BOARD OF MAYOR AND ALDERMEN MEETING AGENDA

RESOLUTION (ID # 3075)

Resolution 35-21, a resolution to approve a special use permit for Union Depot residential mixed use development located at 6896 Highway 70 within the "RS-10" single family residential and "O-R-1" office zoning districts.

UNION DEPOT

STREET TYPE A

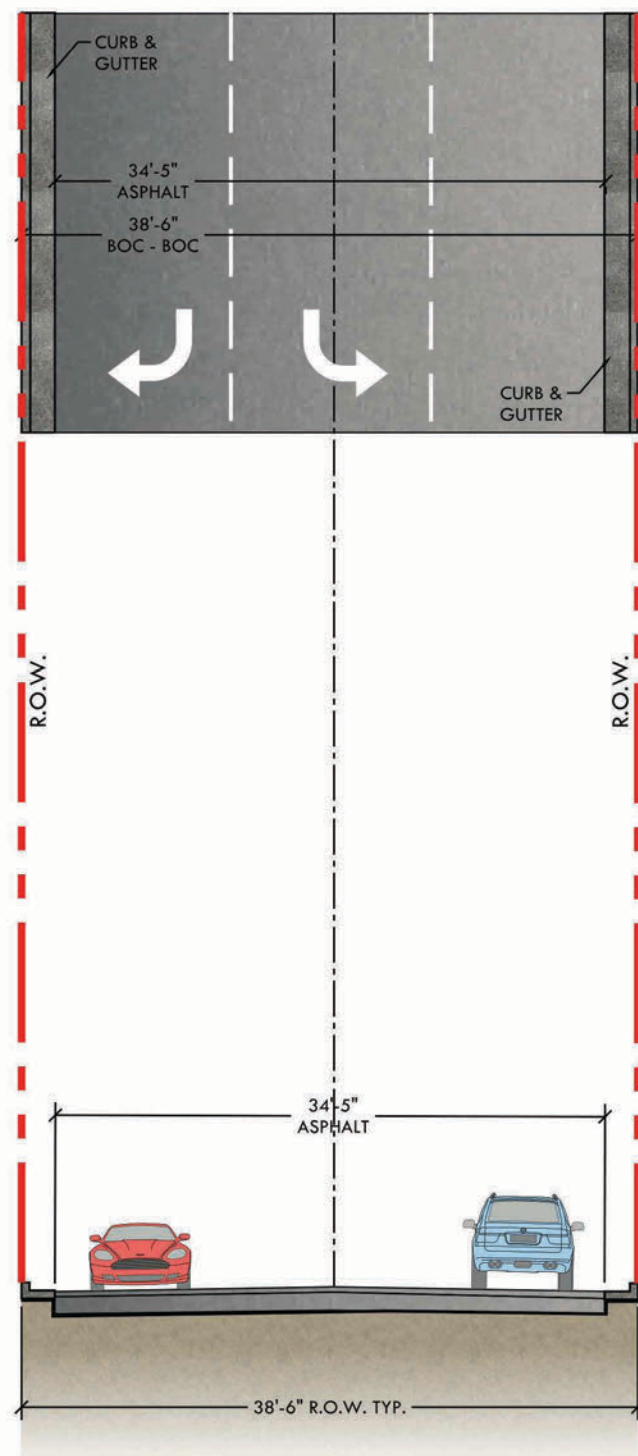
- 20) The exit to Kirby Whitten and Summer should be "Street Type A" or larger to allow at least a few cars to stack, waiting to make a left turn onto Kirby Whitten, while allowing right turners to pass.

TRAFFIC CIRCLE

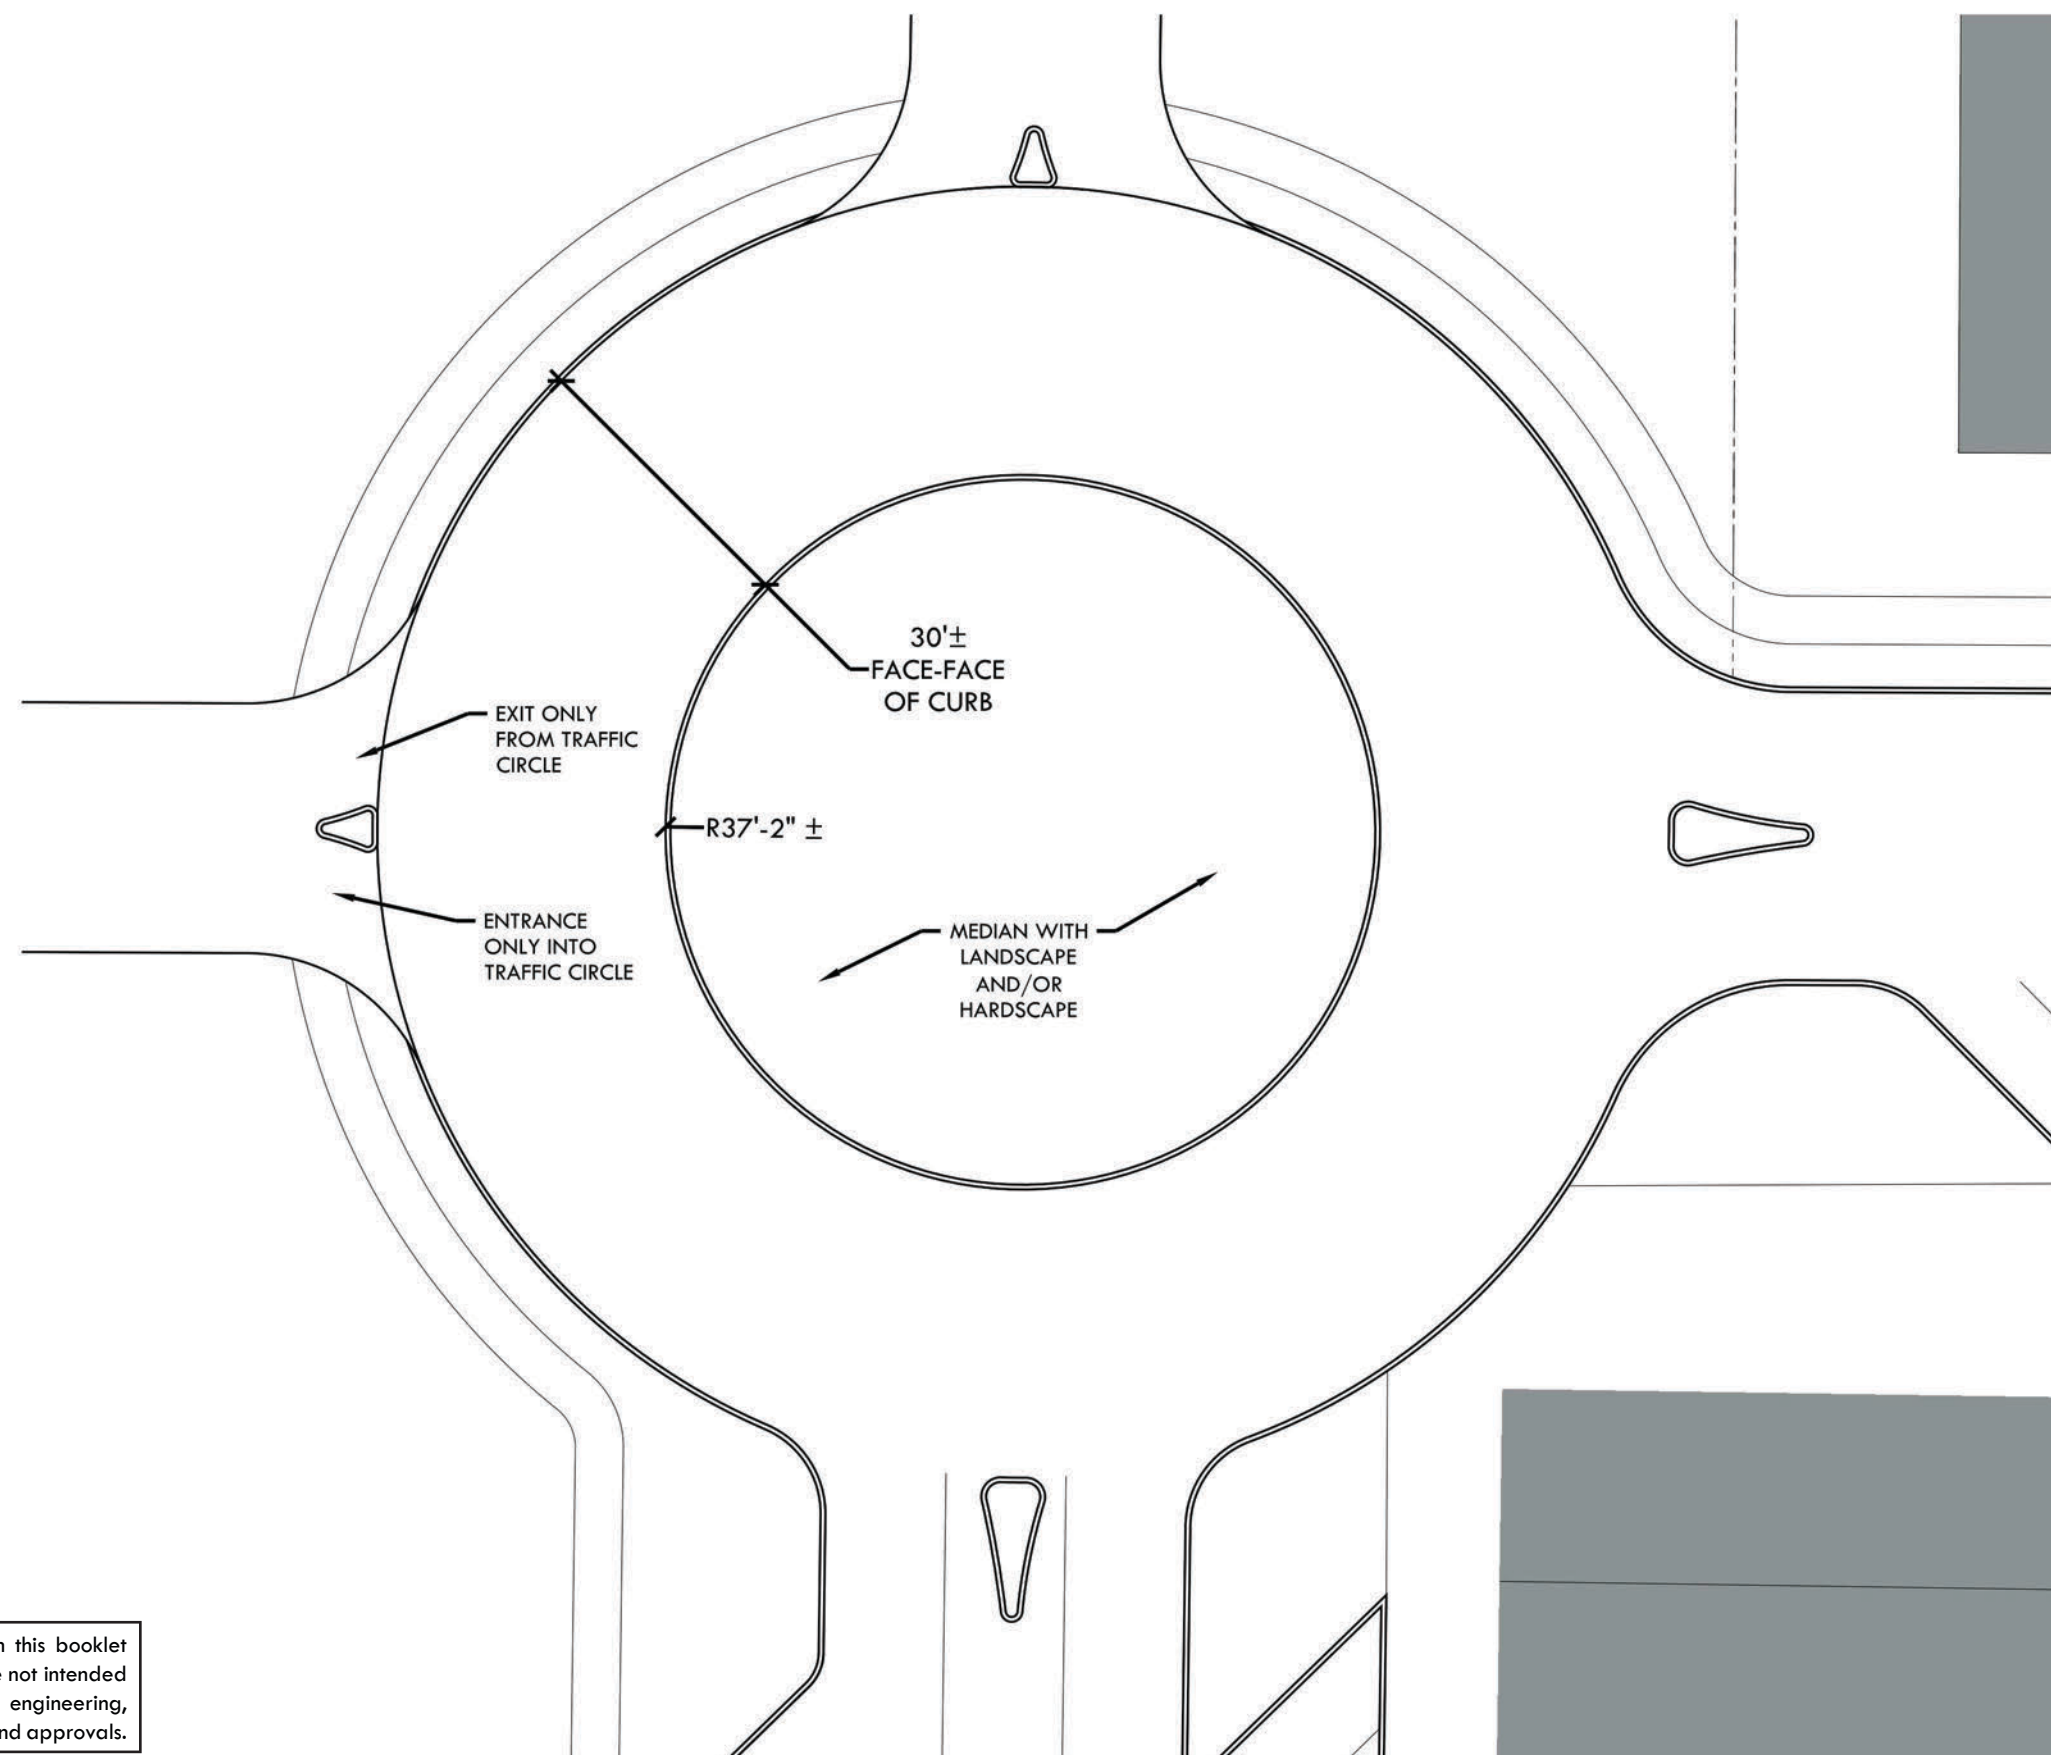
- 21) Who is responsible for maintaining the middle of the traffic circle? Will this be Common Open Space?
- 22) The road around the traffic circle is 30' wide. Is that one lane? Is parking allowed on the outside edge?

- 25) Sign easements are needed for signs.
- 26) Item VII C should include "If this design requirement changes redesign of the site will be necessary."
- 27) Design of the roundabout must meet ADA requirements.

VALLEY CURB & GUTTER, TYP. - NTS

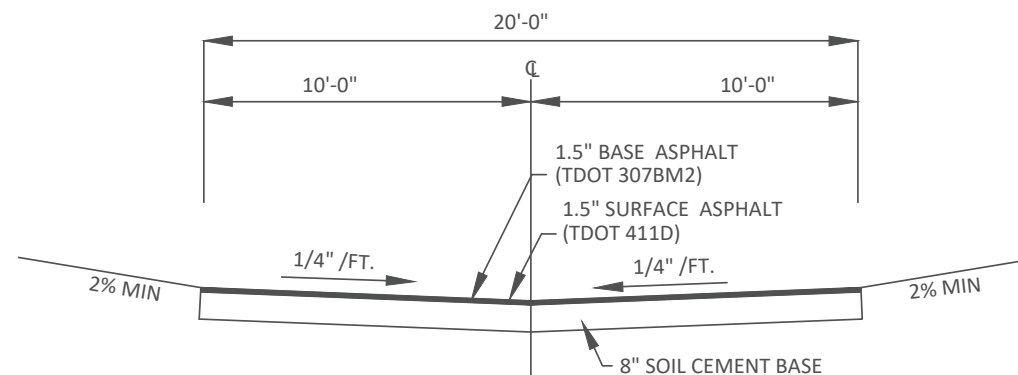
- 28) Valley Gutter is shown on the proposed cross-section. Bartlett typically uses 6-18 or 6-30 curb and gutter. Valley Gutter has been an issue for the city in the past and we recommend it not be used.
